**SUBDIVISION,
PLANNED UNIT DEVELOPMENT (HOLDOVER),
& SIDEWALK WAIVER
STAFF REPORT****Date: August 17, 2017****DEVELOPMENT NAME**

Davenport Properties, Unit Three Subdivision

LOCATION401 Cochrane Causeway
(West side of Cochrane Causeway, 600'± North of Sixth
Street)**CITY COUNCIL
DISTRICT**

SITE PLAN

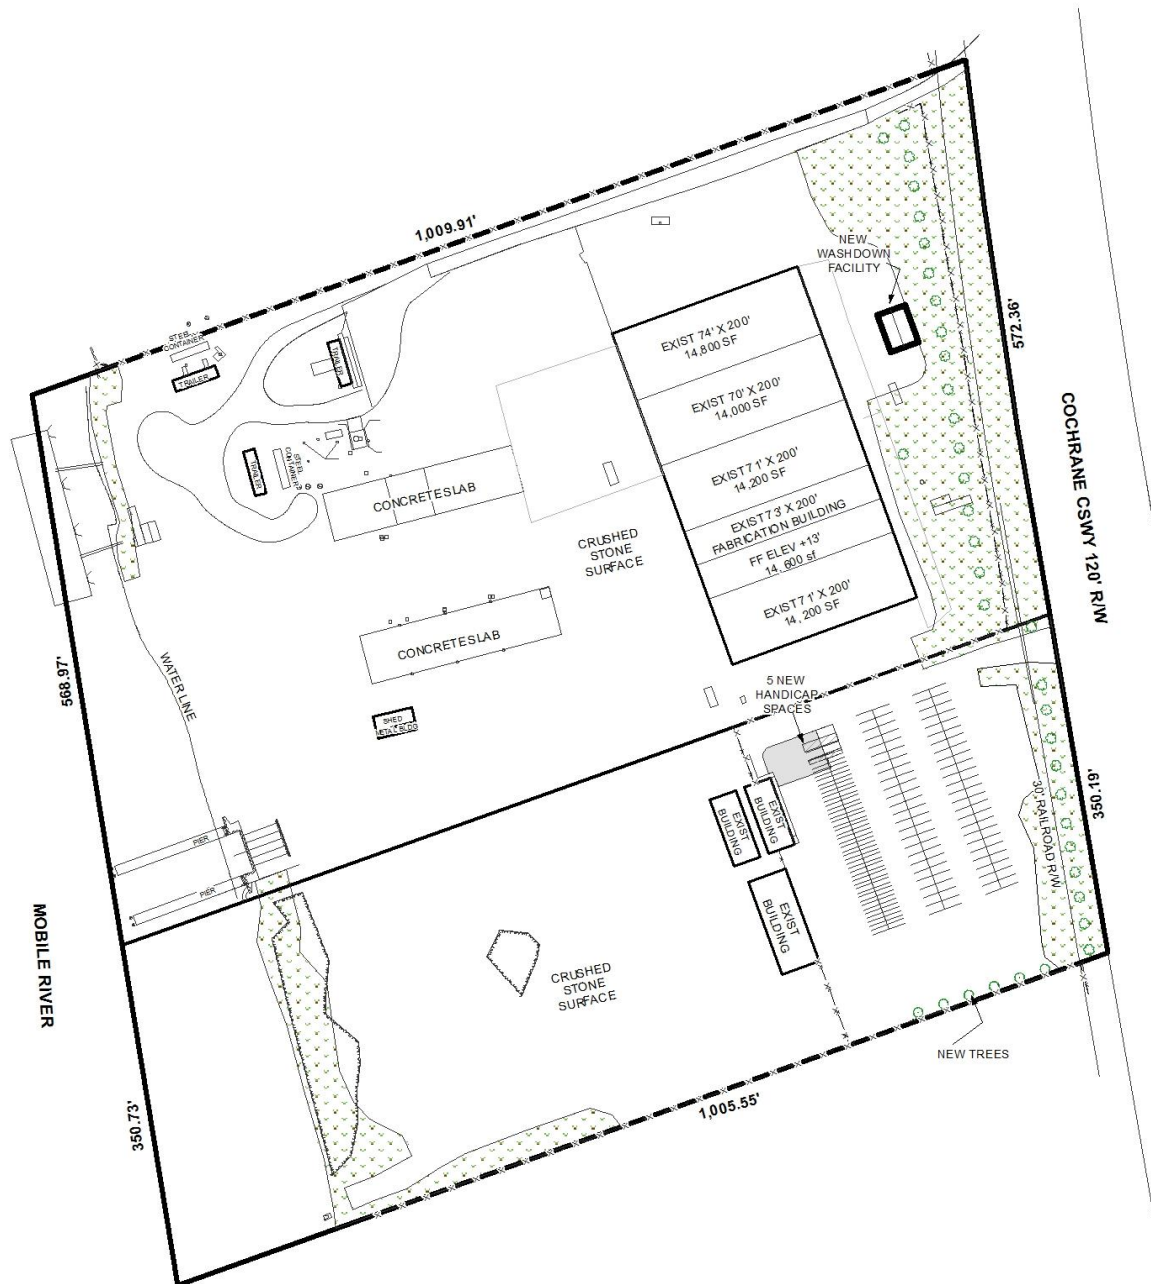
With regard to the revised and expanded PUD, the site plan indicates three existing office buildings on the Southern property with a parking lot which will serve both properties. The parking lot is indicated to be gravel-surfaced, allowed in I-2 districts, with 5 handicap parking spaces on asphalt paving. Parking calculations indicate that 67 parking spaces are required, and 140 are provided, plus the 5 handicap spaces, for a total of 145 spaces. The site plan does not indicate bumper stops for the parking spaces; therefore, the site plan should be revised to indicate that bumper stops will be provided for nose-to-nose parking.

Both properties are accessed via substandard drives from Cochrane Causeway with entrance gates. However, the site plan does not indicate sufficient vehicle queuing space (60') within the site from the right-of-way to the gates. Therefore, the site plan should be revised to indicate compliant 24' wide paved access drives with 60' vehicle queuing space between the right-of-way and the gates. A note should also be placed on the site plan stating that each property is limited to its existing curb cut to Cochrane Causeway, with the size, location and design to be approved by Traffic Engineering and conform to AASHTO standards.

The site plan states that there are existing frontage trees along the Southern property; however, a staff visit to the site revealed that frontage trees were only present within the Northern property and not the Southern property. Therefore, the site plan should be revised to indicate frontage trees are proposed within the Southern property. The site plan indicates understory parking trees are proposed. However, since the site is zoned I-2, only frontage trees are required and the parking trees may be eliminated. It should be noted that since the parking area provides for more than 25 parking spaces, a photometric lighting plan will be required along with site plans at the time of submitting for site improvement permits.

The site plan should be revised to illustrate the 25' minimum building setback line along Cochrane Causeway for both properties.

No public sidewalk is indicated along the Cochrane Causeway frontage. In the event the Sidewalk Waiver request is denied for the Southern property, the site plan should be revised to indicate a compliant public sidewalk along Cochrane Causeway.

- 1) revision of the site plan to indicate bumper stops will be provided for nose-to-nose parking;
- 2) obtaining of after-the-fact building permits for the three existing office buildings on Parcel R022905000002008 (the Southern property);

- 3) revision of the site plan to provide compliant 24' wide paved entrance drives for both properties with 60' vehicle queuing space between the right-of-way and the gates;

- 4) placement of a note on the site plan stating that each property is limited to its existing curb cut to Cochrane Causeway, with the size, location and design to be approved by Traffic Engineering and conform to AASHTO standards;

- 5) revision of the site plan to indicate that heritage frontage trees are proposed within the Southern property;
- 6) revision of the site plan to illustrate the 25' minimum front building setback line along Cochrane Causeway for both properties;

- 7) revision of the site plan to indicate a public sidewalk along Cochrane Causeway for the Southern property in the event the Sidewalk Waiver is denied for that property;
